ATTACHMENT A

Revise Appendix A as follows:

Proposed Change Request No. 106 amends the Beaver Valley Power Station, Unit No. 1 Technical Specification Administration Controls section to reflect the Nuclear Group reorganization, update the index and delete blank pages.

FIGURE 6.2-1
CORPORATE ORGANIZATION (PARTIAL)

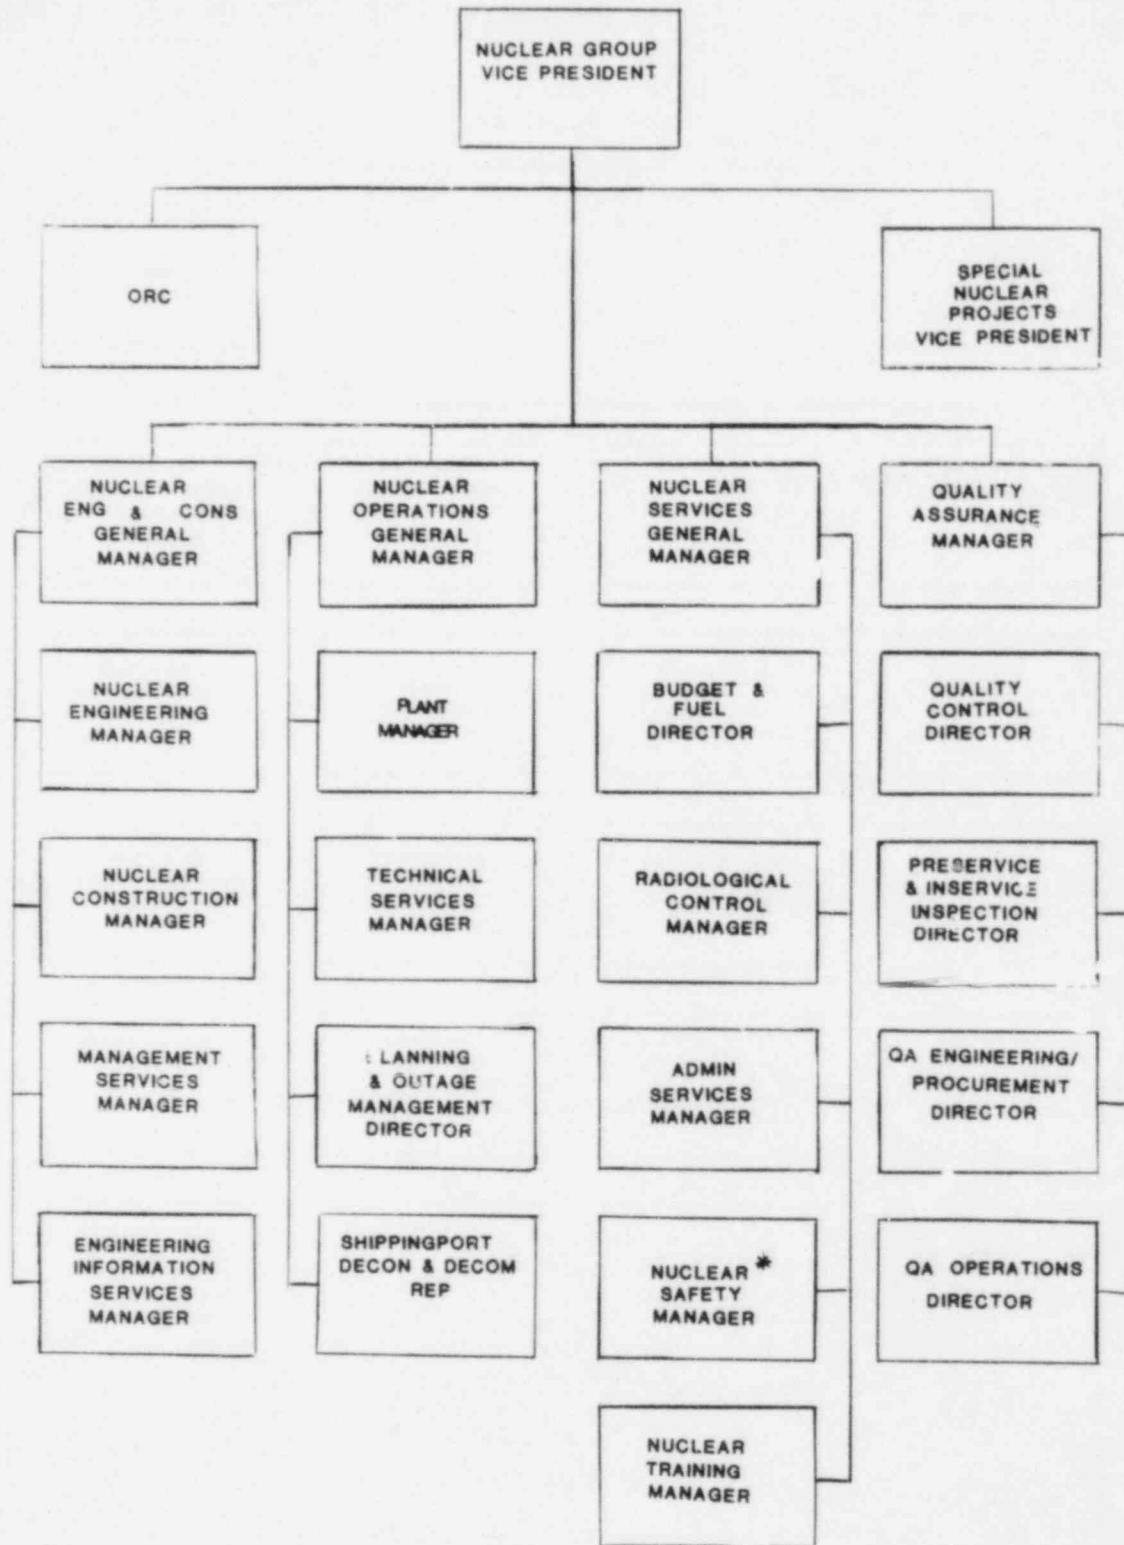
Figure 6.2-1, revised the titles of the next level of management reporting to the General Managers and incorporated the next level of management reporting to the Quality Assurance Manager. The title of this figure has been revised to "Corporate Organization (Partial)".

FACILITY ORGANIZATION
FIGURE 6.2-2

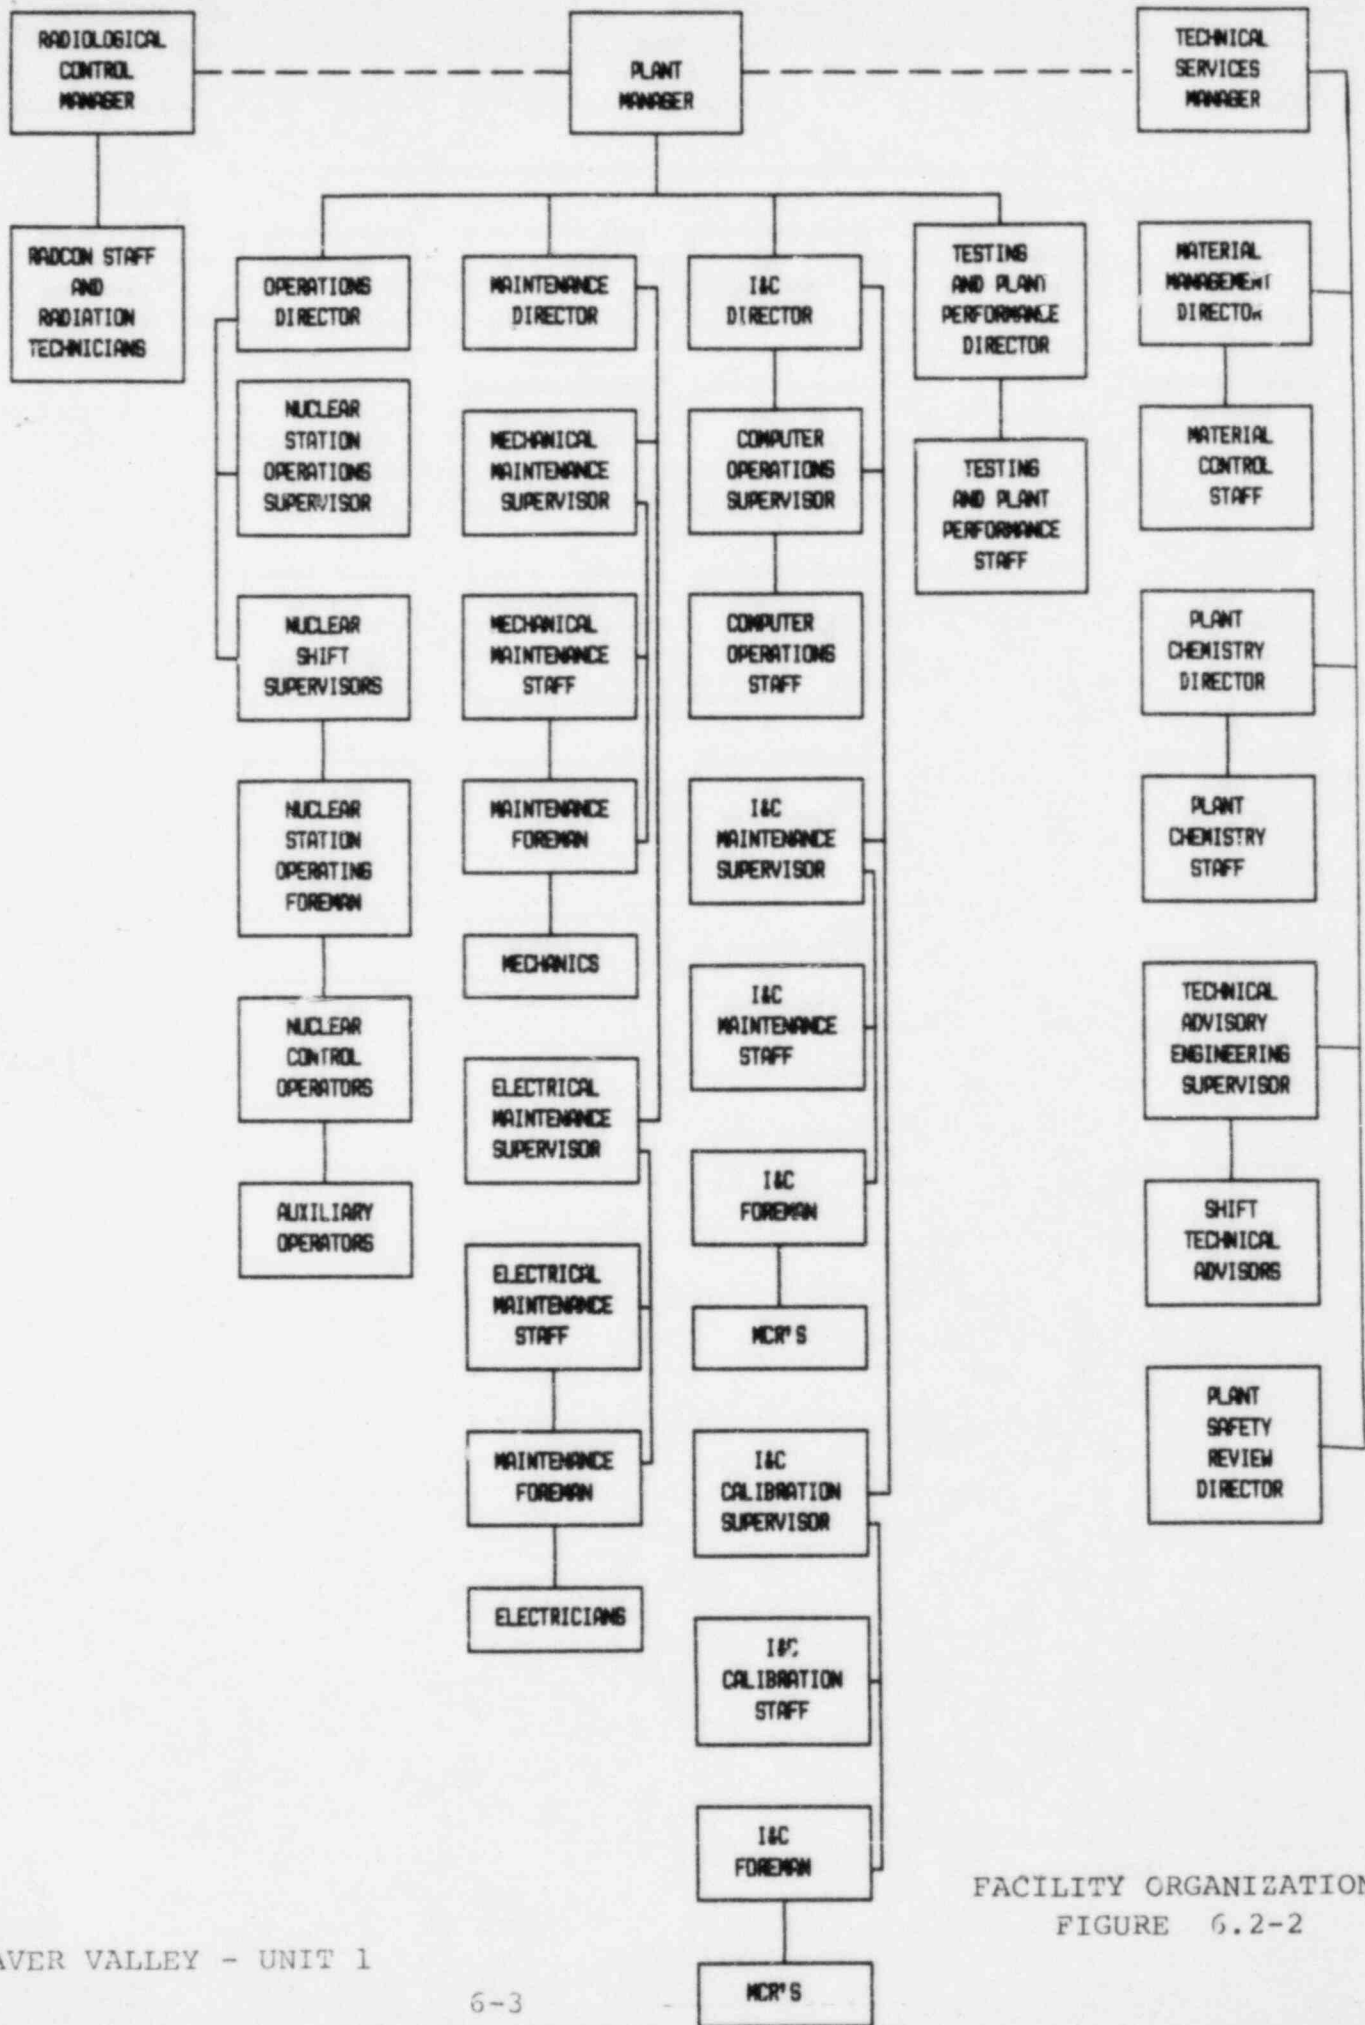
Figure 6.2-2, revised the Facility Organization chart to identify the new titles of the personnel reporting to the Plant Manager and Technical Services Manager.
